EIR-81-5

EAST "J" STREET CONDOMINIUMS

prepared by
City of Chula Vista Planning Department
Environmental Section

Issued by
Environmental Review Committee
July 23, 1981

FIG 1

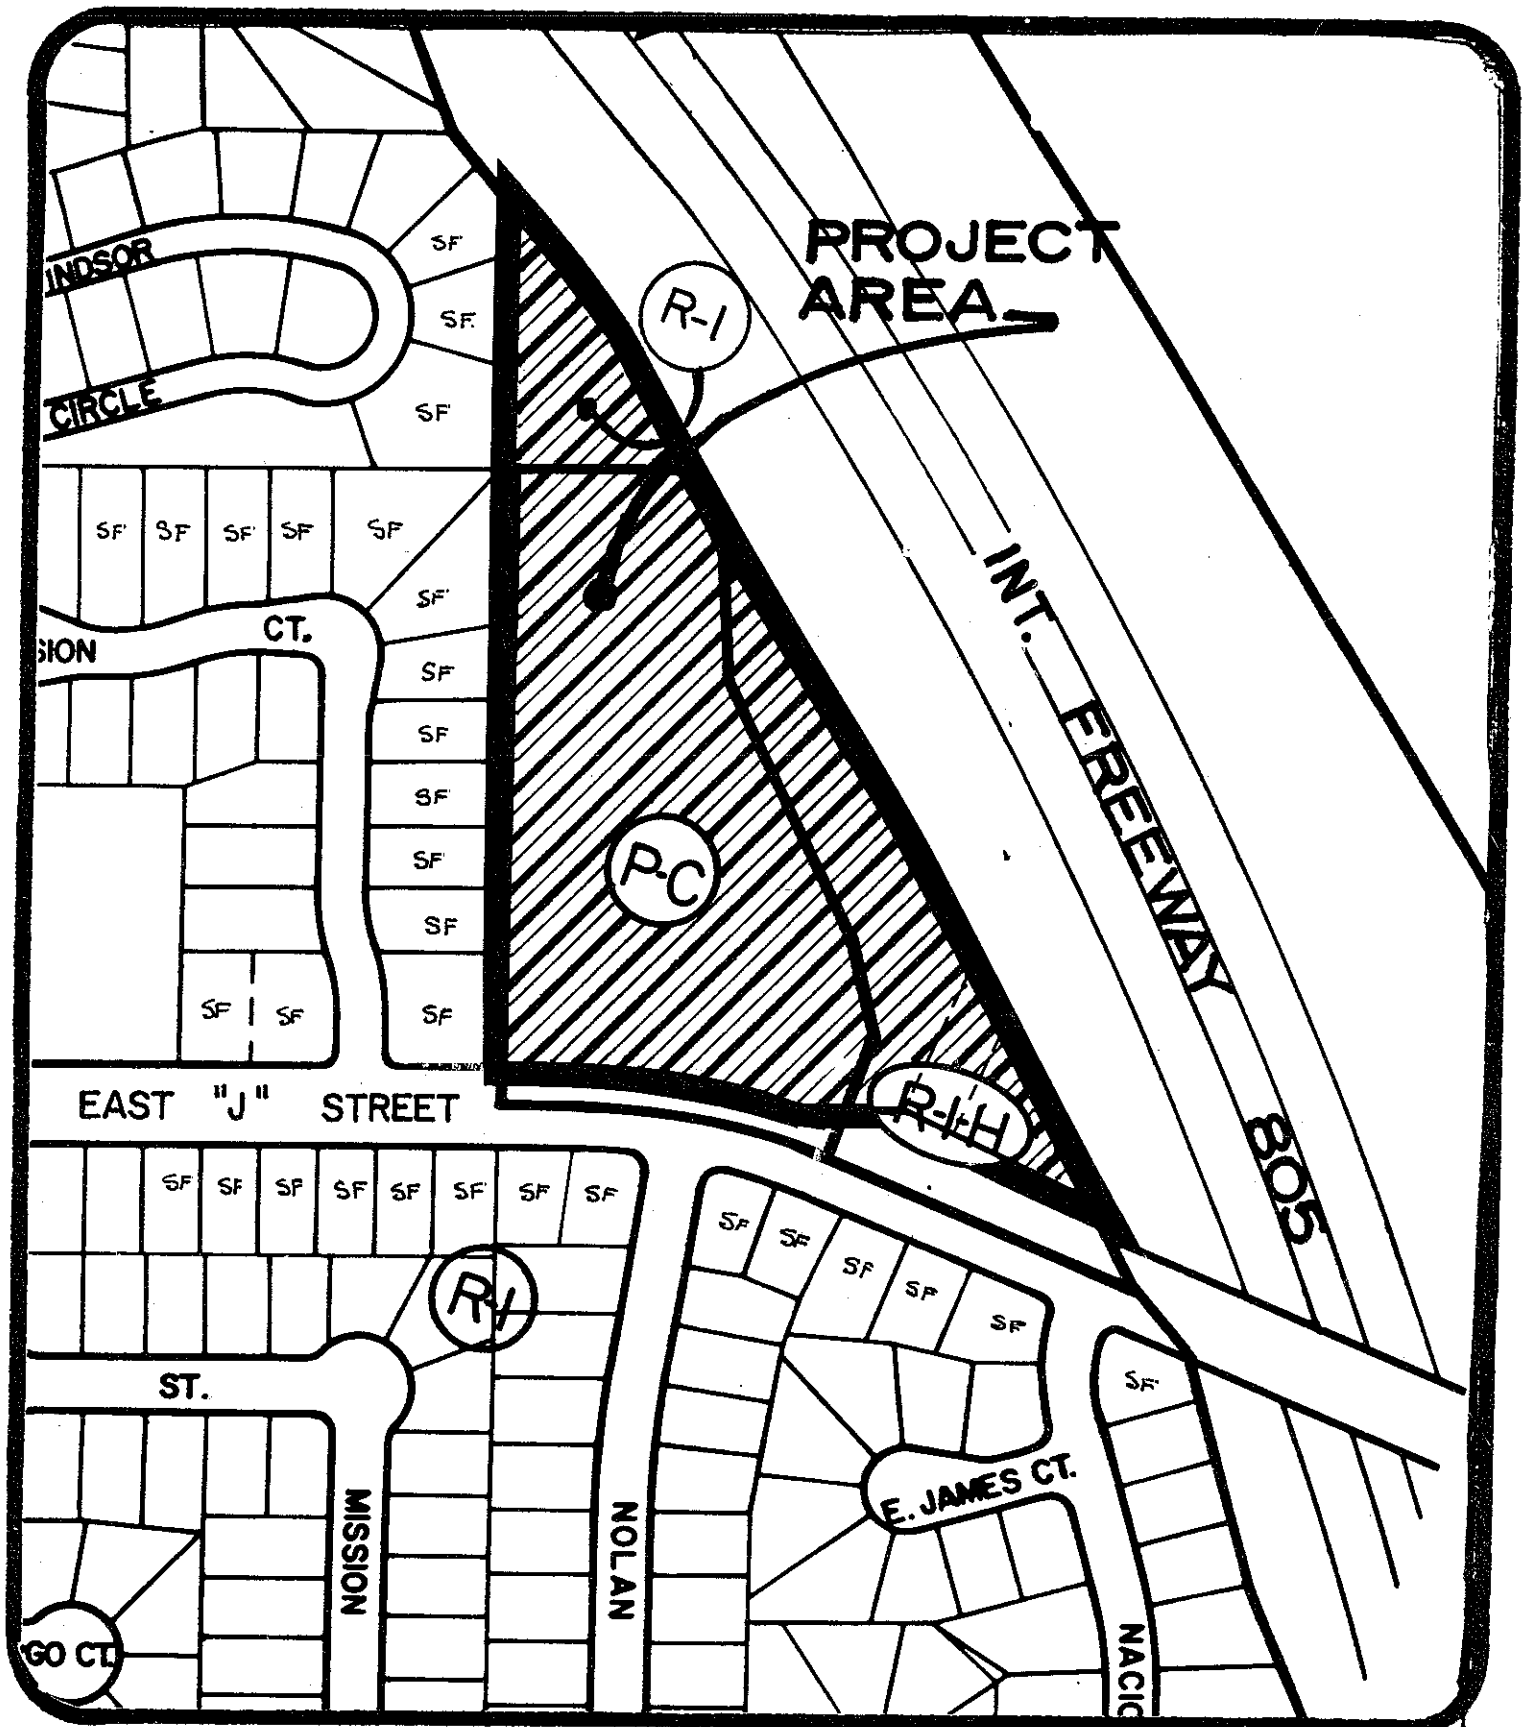
Short: Okay. Now, your locator, figure 2, there's supposed to be R-1 lots within that development, and it's not designated.

The questions regarding the locational map, figure 2, in the EIR are acknowledged and the figure has been modified to provide clarity in the zoning of the subject property.
